**Comments of Public Service Company of New Hampshire**

**EPA's Revised Draft National Pollutant Discharge Elimination System**

**Permit No. NH 0001465**

**Merrimack Station**

Figure 4-4  
Monfalcone Power Station - FGD Treatment System Flow Schemati

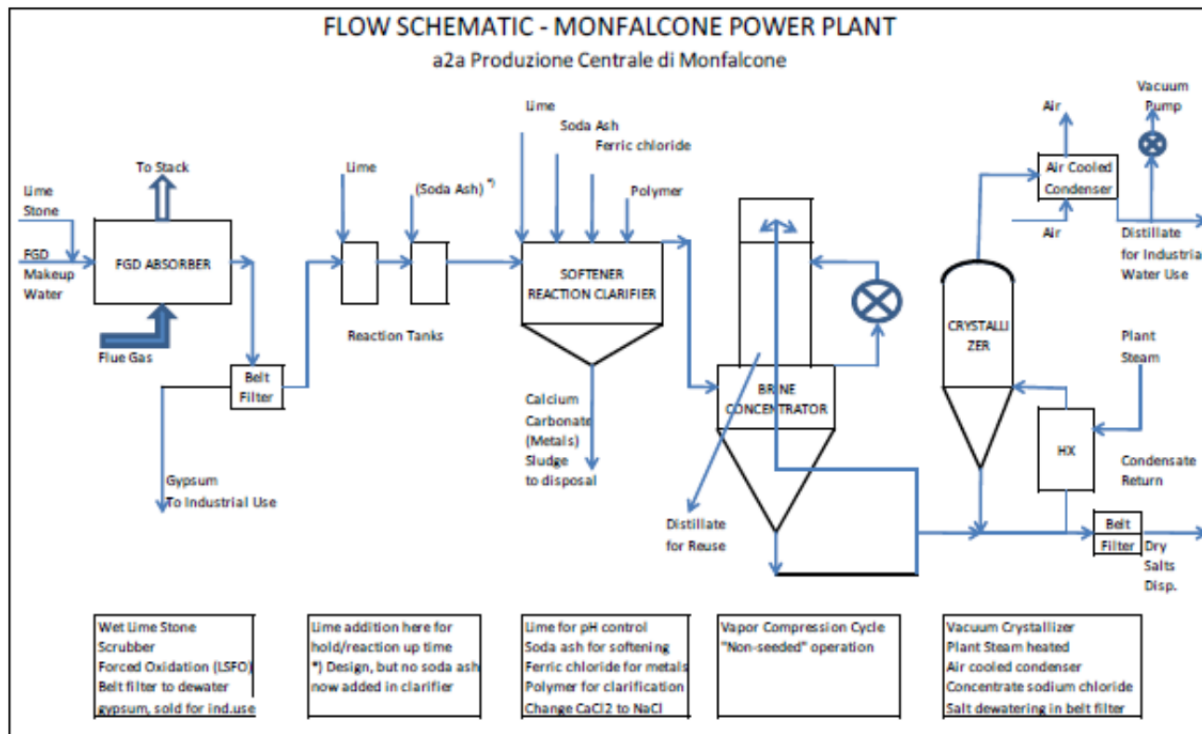
A block flow diagram for the system (from the facility’s permit), plainly shows a discharge from the system (labeled “Distillate for Industrial Water Use”).

Thus, the system does not achieve complete ZLD.
